HPT Data

From: Leo Brausch <Lbrausch@brauschenv.com>
Sent: Monday, July 8, 2019 3:21 PM
To: Kolak, Shari
Cc: 'Kratzmeyer, Jack'; Gates, Ellyn; Pennington, Andy; Darby, Thomas; Susan Franzetti
Subject: LCCS Reference Materials
Attachments: Pre-Meeting Submittal 1. Soil Boring Logs Used in Cross Section.pdf; Pre-Meeting Submittal 4. HPT with Summary of Lithology.pdf

The two attached files provide information requested in your 6/17/19 email regarding the evaluation of the clay confining unit at LCCS. The first provides the logs of soil borings that were used to construct cross-sections (Comment 1). The second provides lithological information on the HPT logs (Comment 4). We plan on discussing this information as well as the other issues you raised during of July 10, 2019 meeting. In the meantime, if you have questions or concerns, please do not hesitate to contact me. Thanks.

SB-HPT-01

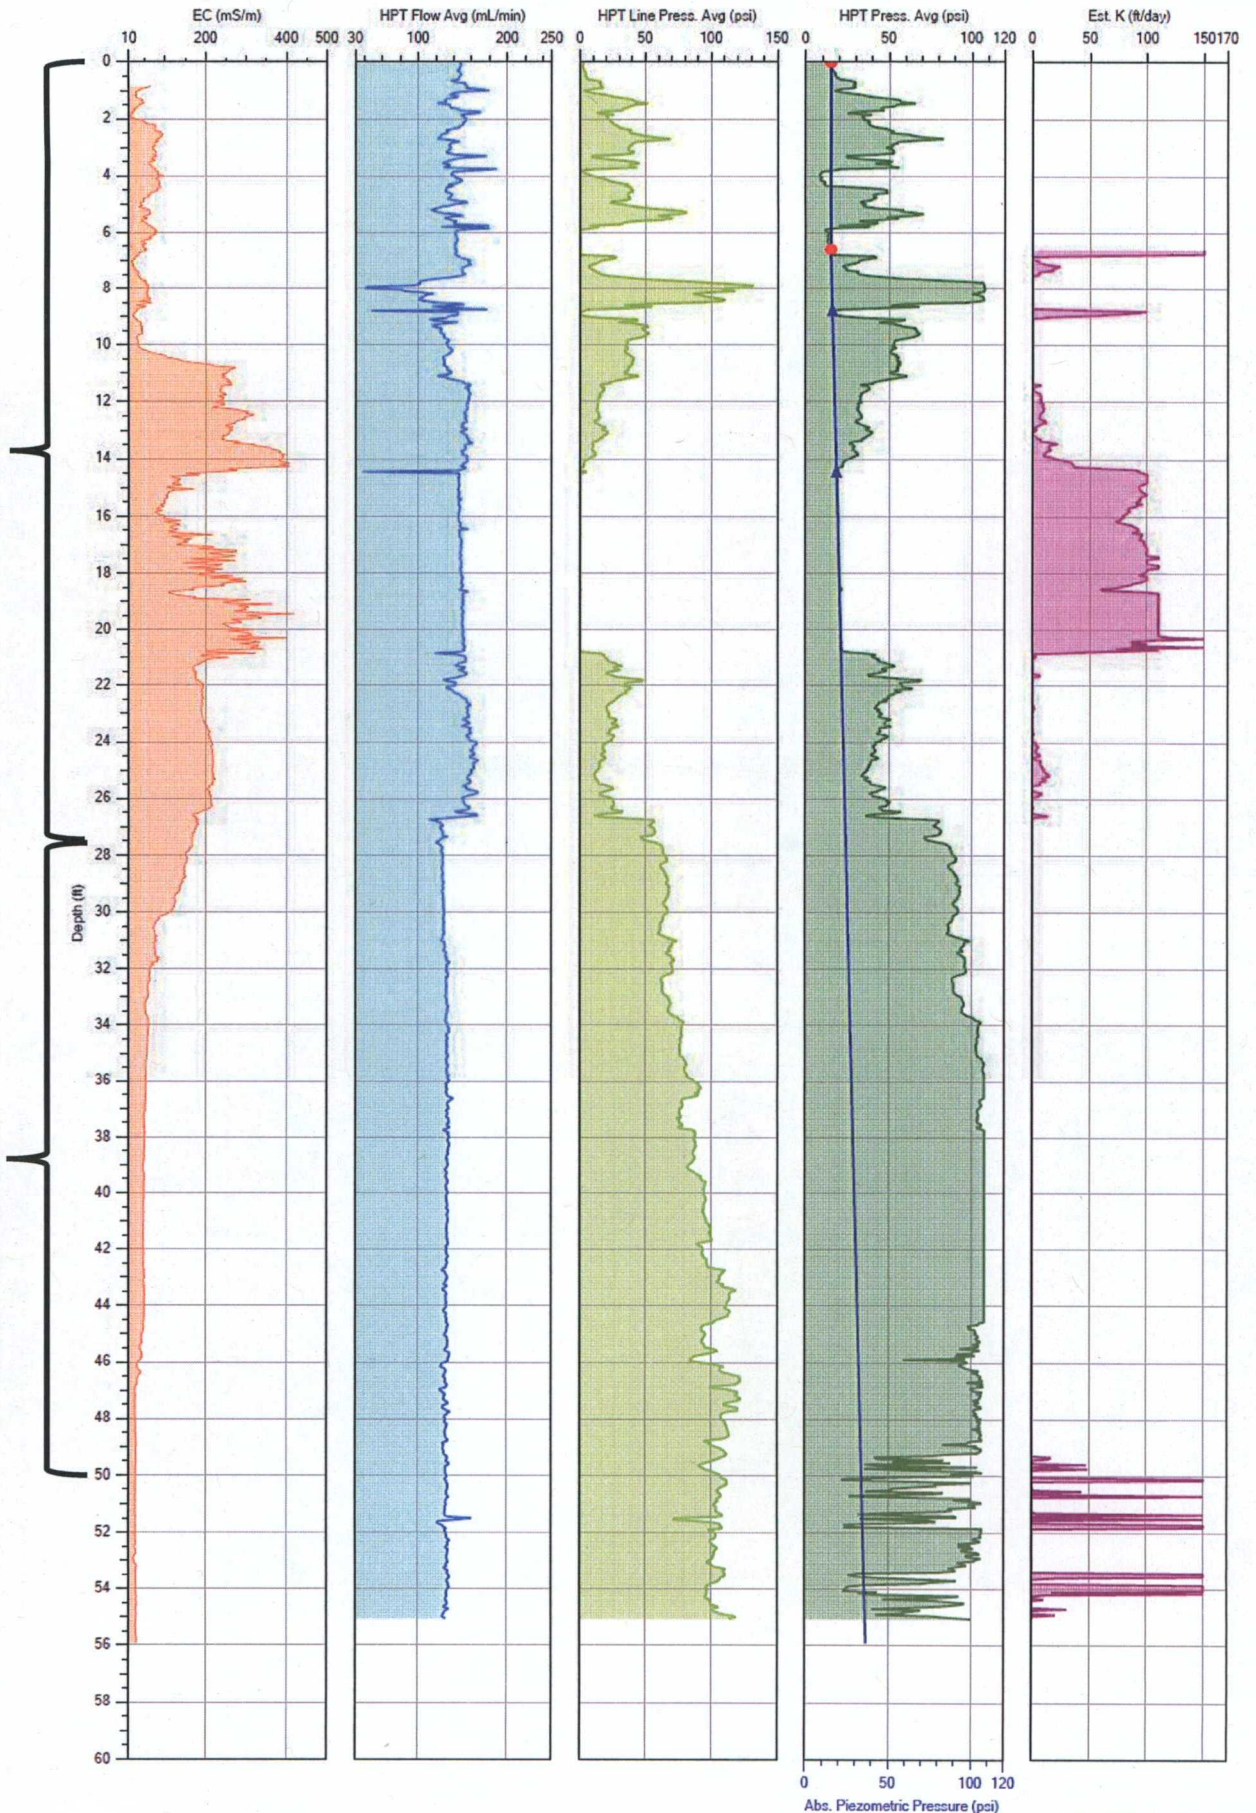
Previously, Paul Lake of the IEPA inquired about specific portions of the hydraulic profiling tool (HPT) logs presented in the Tech Memo (Arcadis 2017), specifically regarding the silty clay unit. Mr. Lake interpreted several of the logs (including those for HPT-01, HPT-10, and HPT-10A) to suggest the presence of a relatively permeable zone atop the silty clay layer that serves as a regional barrier to vertical groundwater migration.

The appearance of a higher-permeability unit in these logs is an artifact of a pressure sensor failure within the HPT equipment, and review of all the sensor data presented in the logs indicates that a permeable unit is not present at the depths in question. When HPT-01, HPT-10, and HPT-10A were completed in 2015, the Arcadis geologist noted that drilling conditions at these locations were more difficult than elsewhere on the Site, leading to greater wear on equipment. In particular, at location HPT-10, the drilling crew noted that the pressure sensor within the drilling tooling failed at a depth of approximately 48 to 49 feet below ground surface (bgs) and required replacement after the boring was complete. A second boring, HPT-10A, was attempted at an adjacent location to obtain more representative pressure data, but a similar sensor failure occurred. The pressure sensor failure resulted in a higher reported estimate of relative hydraulic conductivity on the HPT log, as shown below. The geologist determined that a unit with a higher silt content was present at these locations and depths, which was causing transducer failure and, thus, HPT logs that were not representative of the true geological conditions.

The attribution of this issue to the pressure sensor failure was confirmed through review of the "line pressure" sensor output on the HPT equipment to the downhole pressure reading on the HPT tooling. The line pressure and downhole pressure sensors both track hydrostatic pressure within the water injection line that runs to the downhole injection port and provide similar relative pressure readings when both sensors are functioning normally. In the case of HPT-01, HPT-10, and HPT-10A, a divergence in the two sensors' output is noted at depth, corresponding to failure of the downhole sensor.
